City of
Richmond

Report to Development Permit Panel

File: DP 11-566011

Re: Application by Omicron Architectural Engineering Construction Ltd. for a
General Compliance Ruling at 15111 Williams Road and Richmond Key 195105

Plan # 5

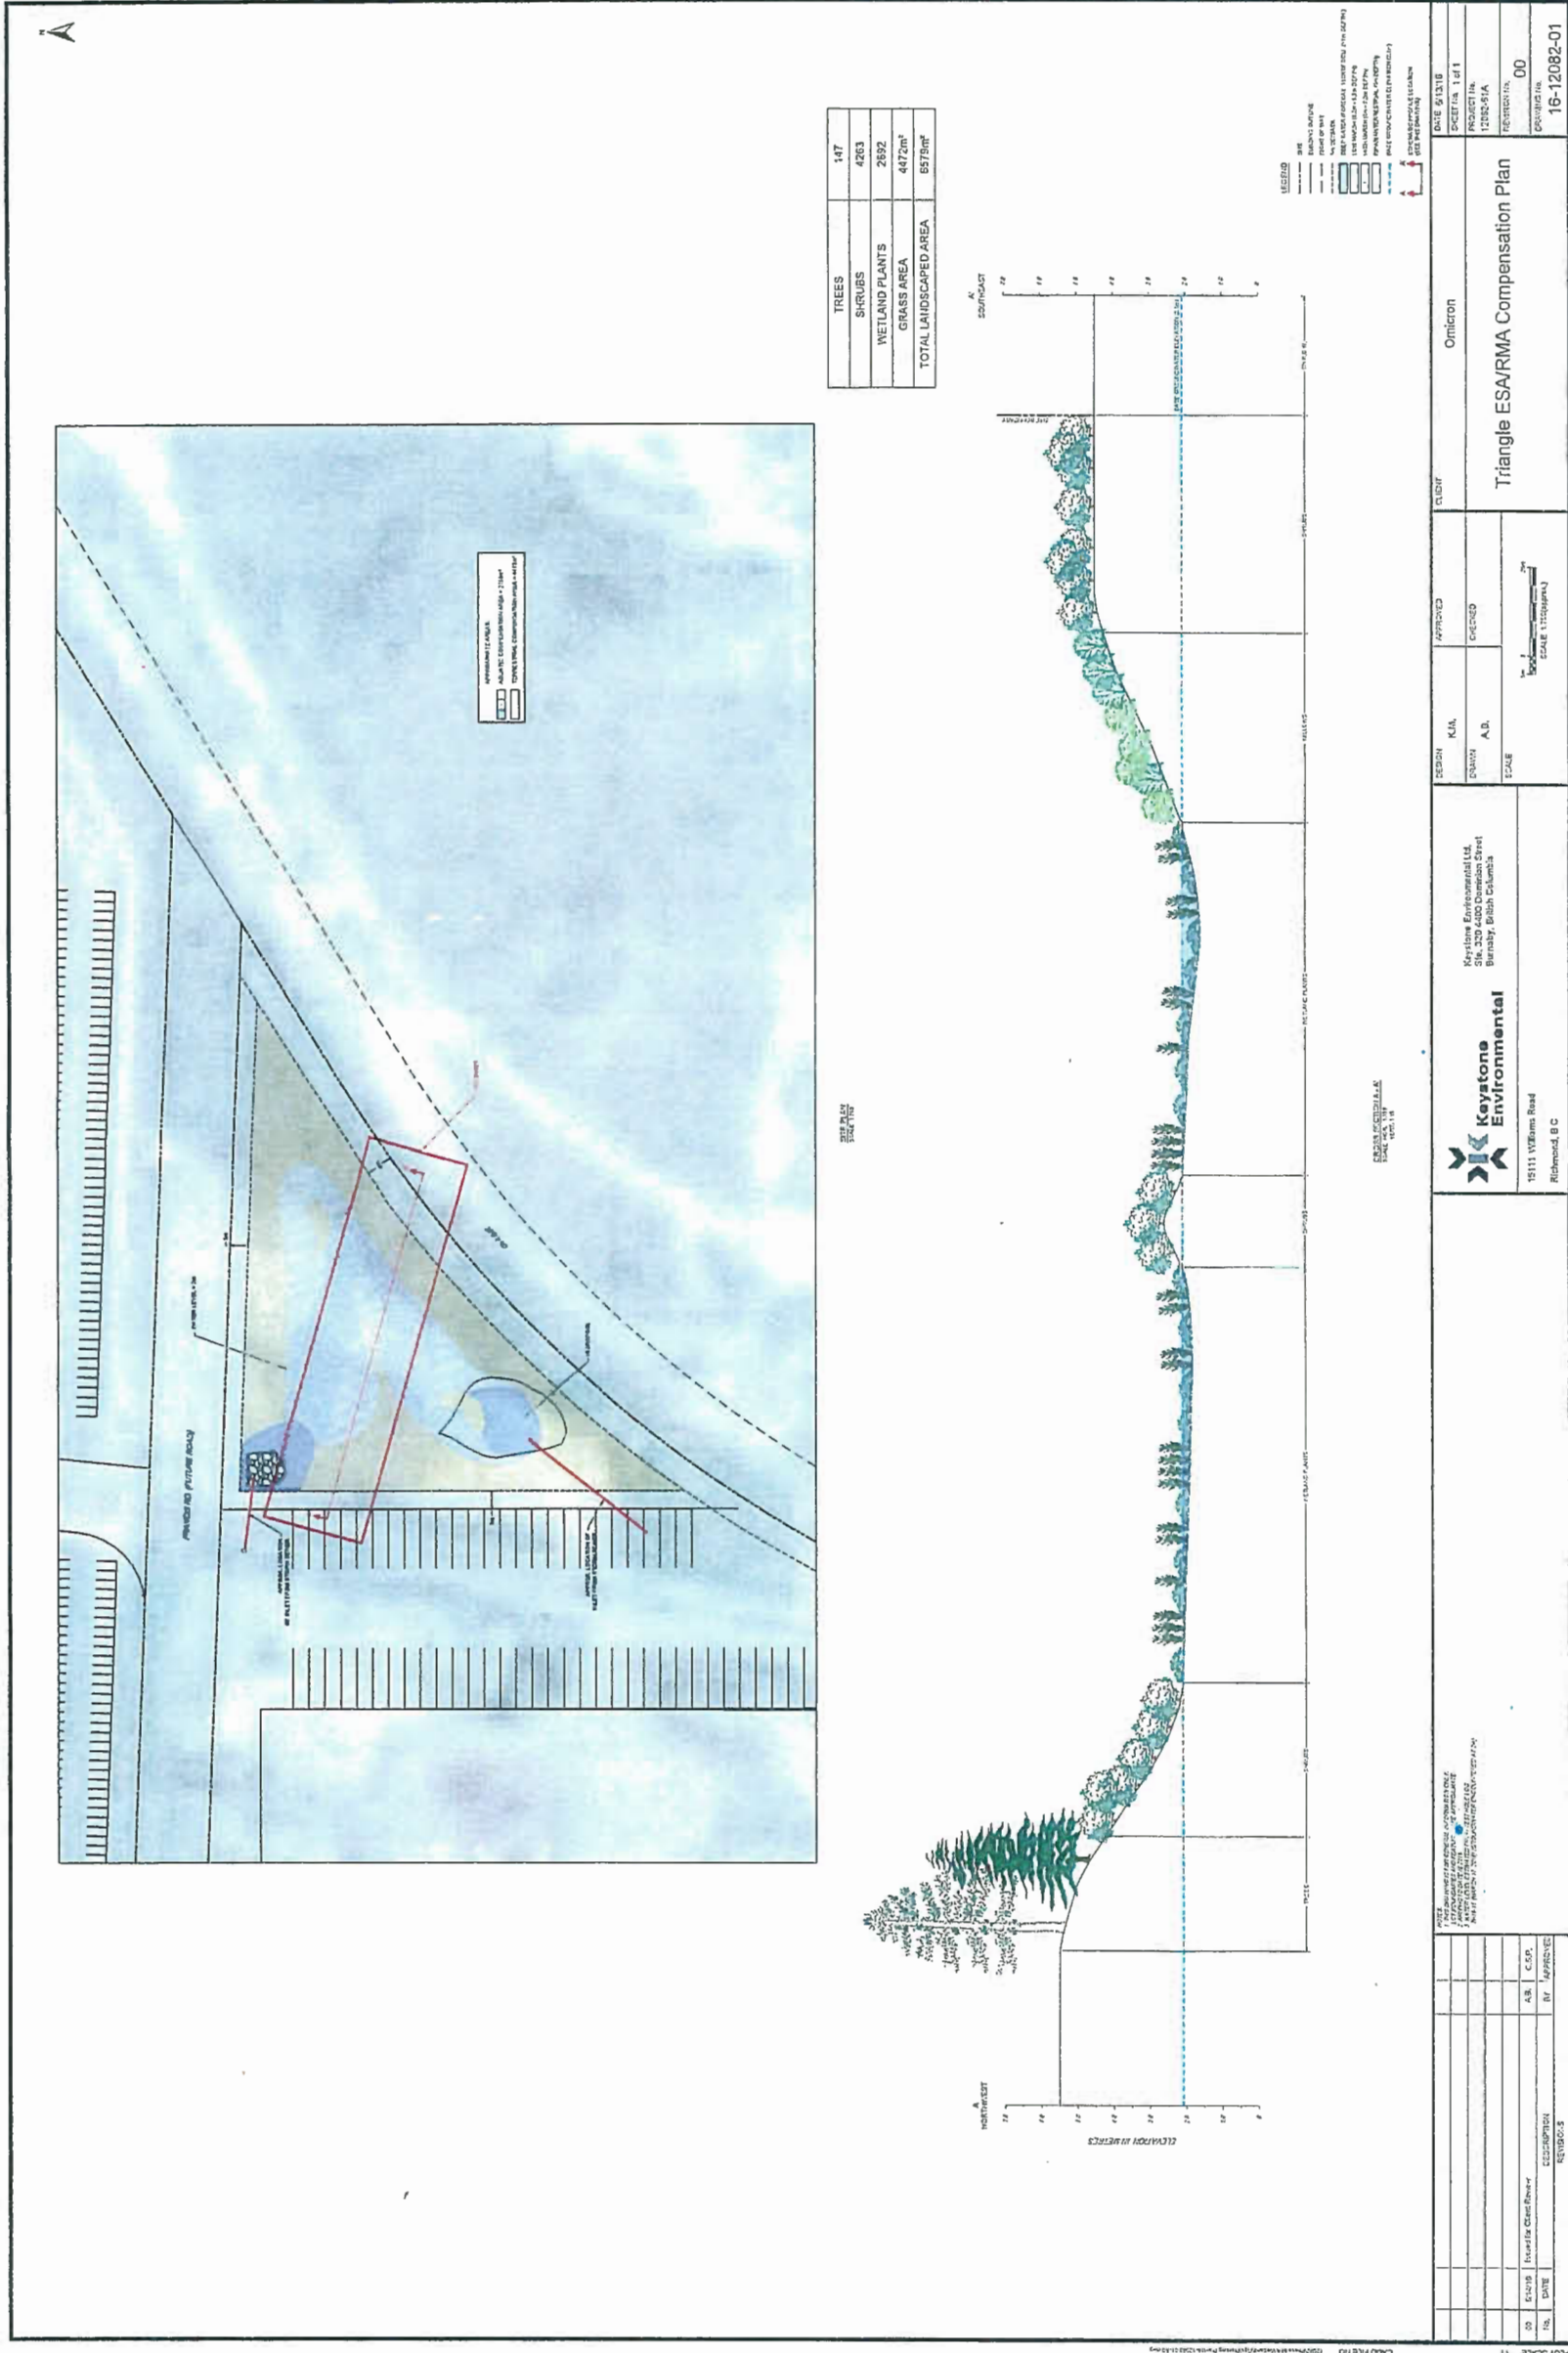
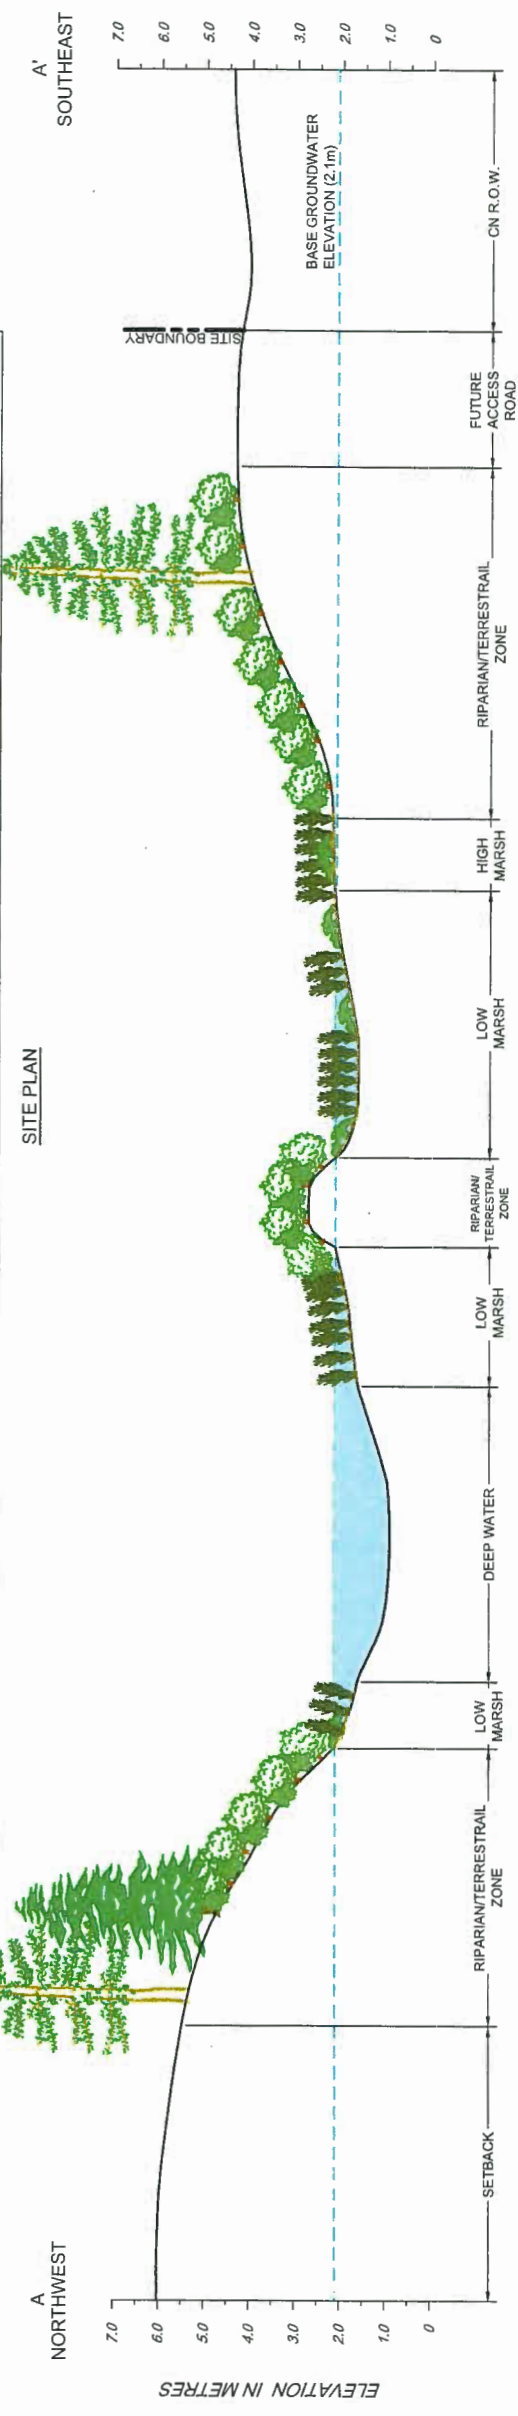
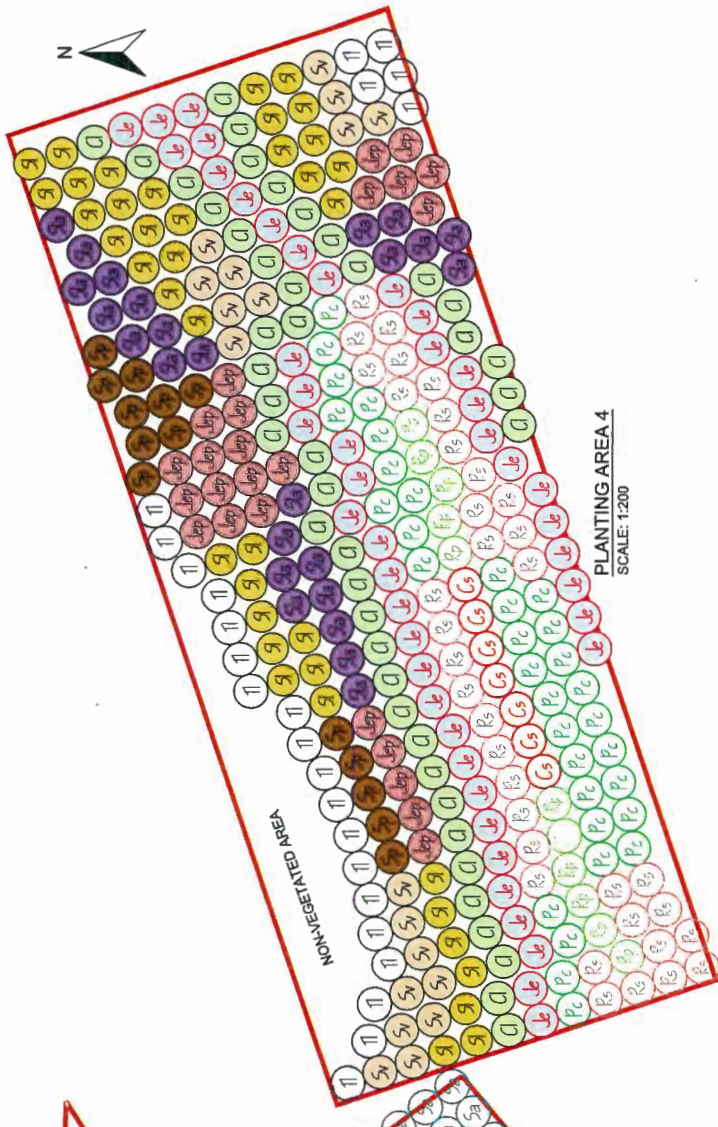
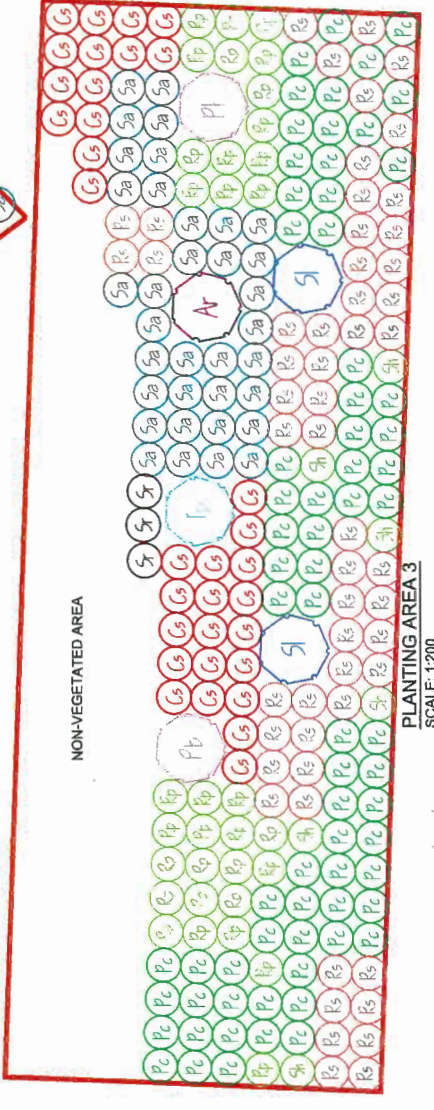
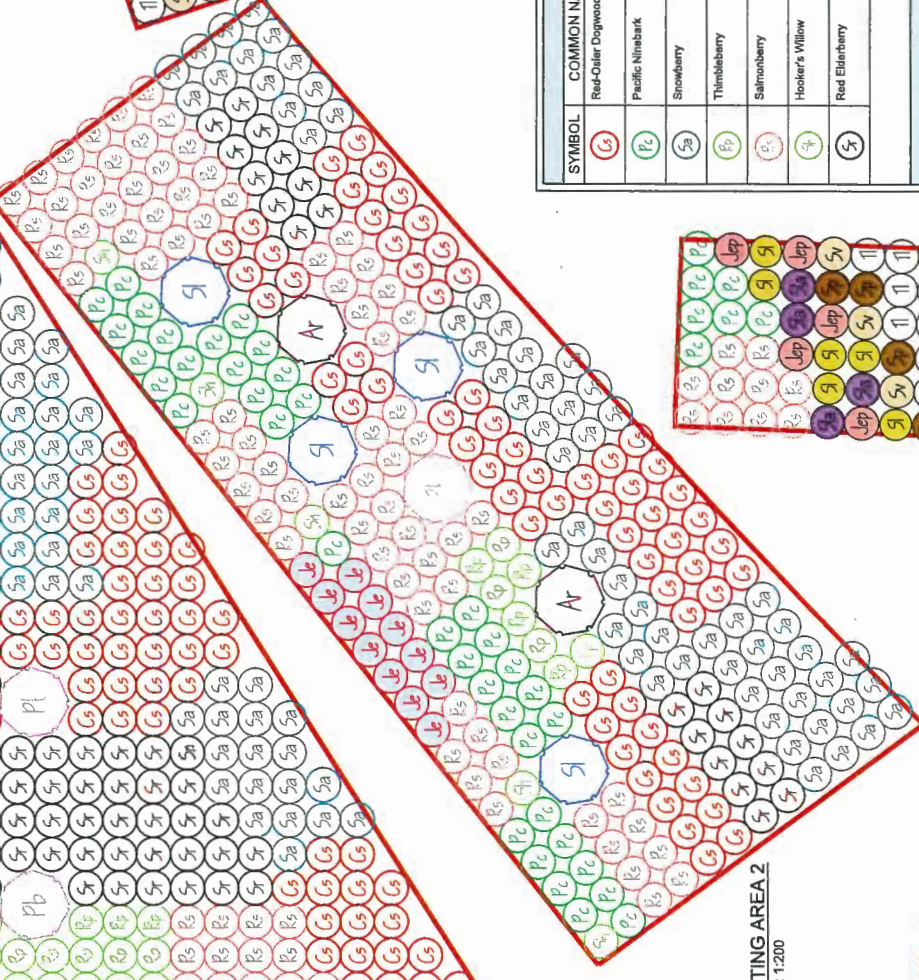
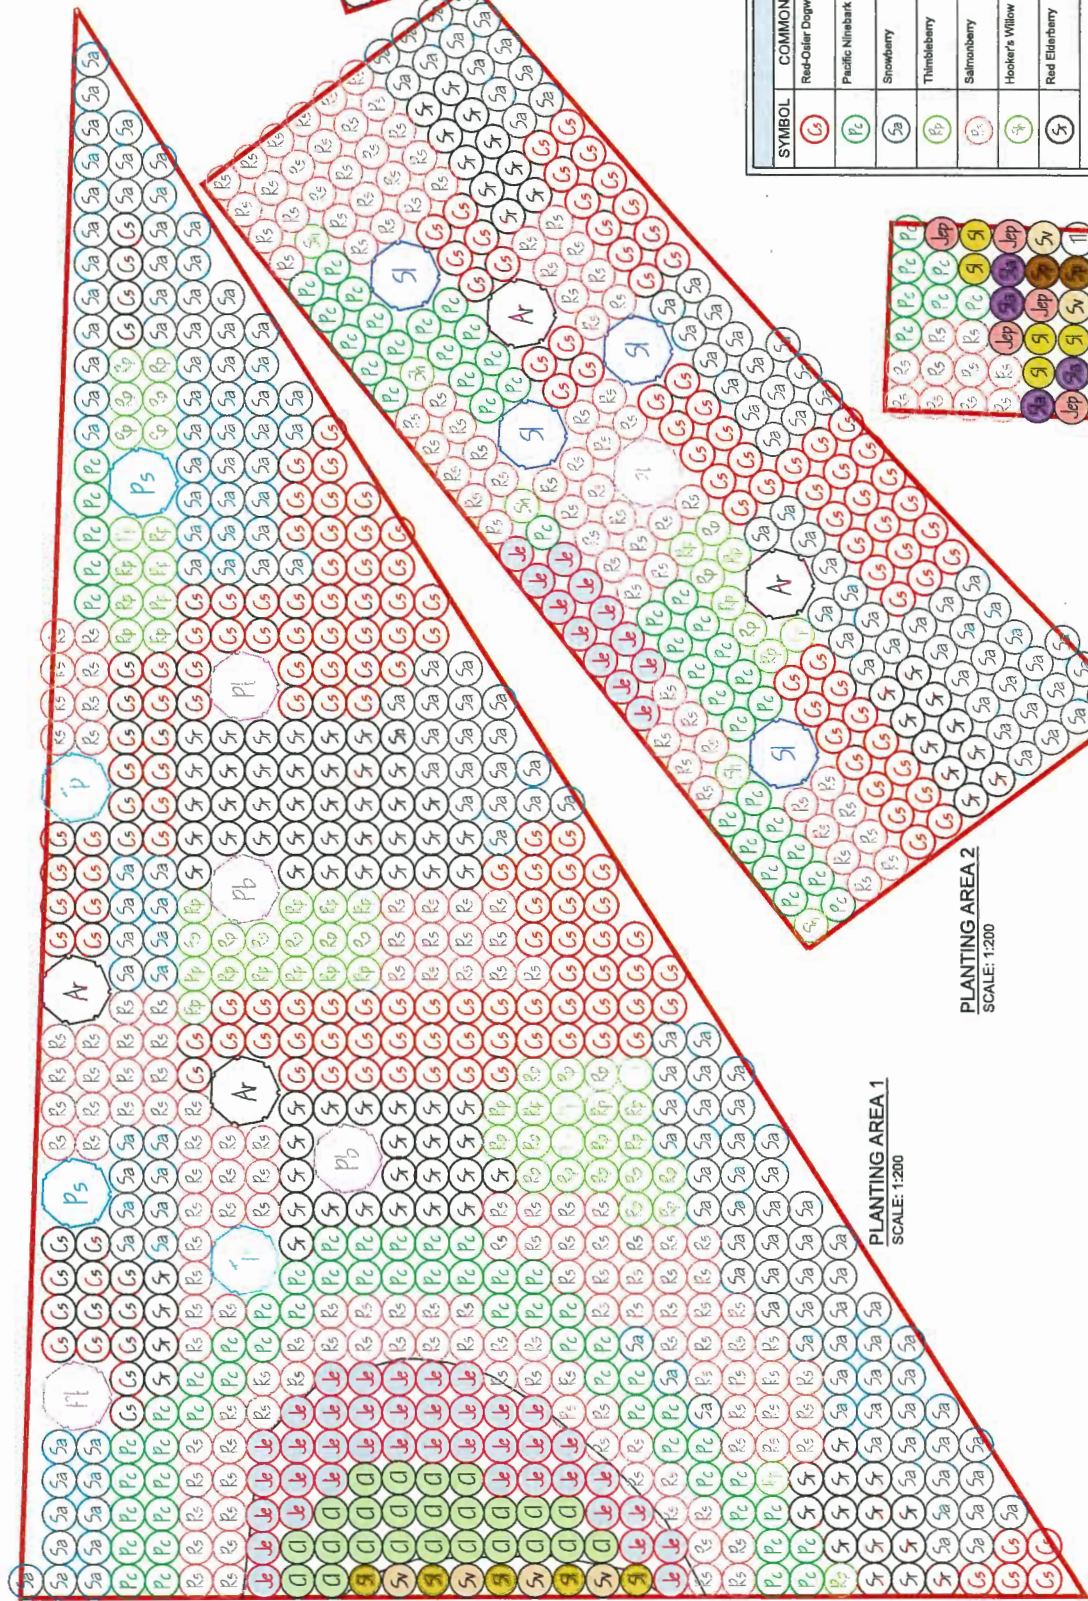
To mitigate the impacts of the 30 m² slope encroachment into the future ESA/RMA compensation area from the extra fill on the Francis Road Right of Way, the applicant’s environmental consultants, Keystone Environmental, have redesigned the proposed compensation enhancement by adjusting the shape of the proposed wetland and its cross section profile. In addition, they have refined the species selection list to better suit the modified terrain. As a result, the revised compensation planting area increases the aquatic net benefit by 952 m² over the approved Development Permit plans to 1,132 m² and increases the terrestrial net benefit by 1,000 m² over the approved Development Permit plans to 5,088 m². Overall, the habitat balance under the revised plan will increase by approximately 22.6%.

New plans are split into Plan 5a and 5b.
